REMARKS

10/824,270

APPENDIX A

AMENDMENT IN RESPONSE TO  
OFFICE ACTION DATED JUNE 29, 2005

FIG. 6A

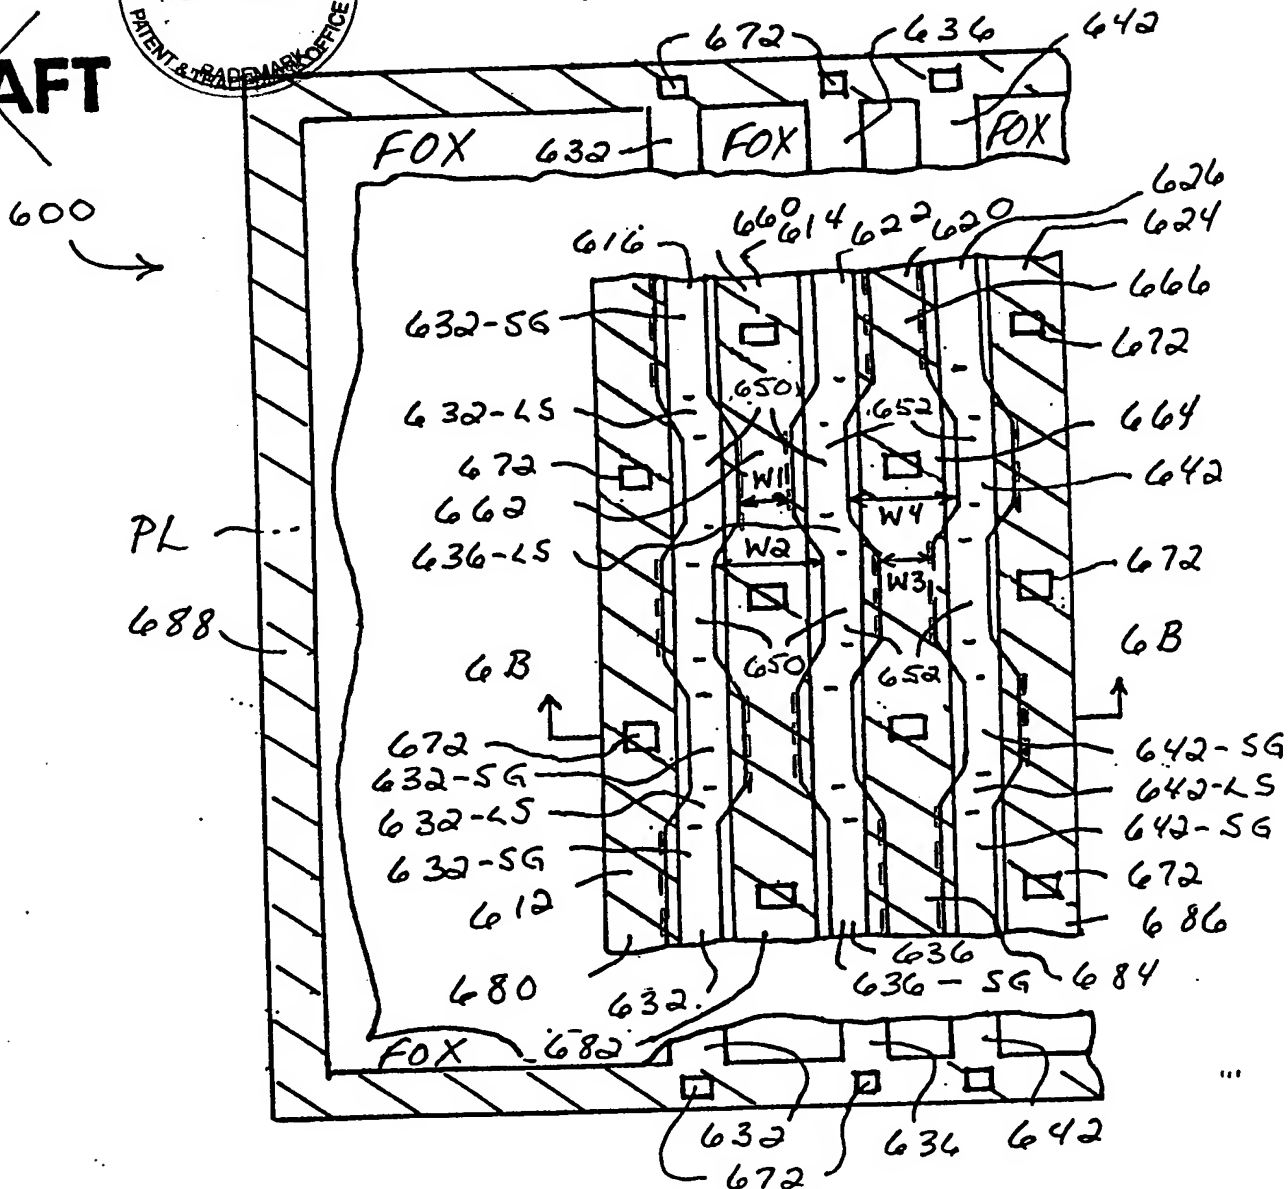
The Examiner objected to the drawings because some of the solid lines need to be replaced with broken lines to clearly show the boundaries of the metal traces, gates, sources, and drain regions in FIGS. 6A, 7A, and 8A. As a result, applicant proposes amending FIGS. 6A, 7A, and 8A as shown in red on marked up informal drawings which are included in Appendix A.
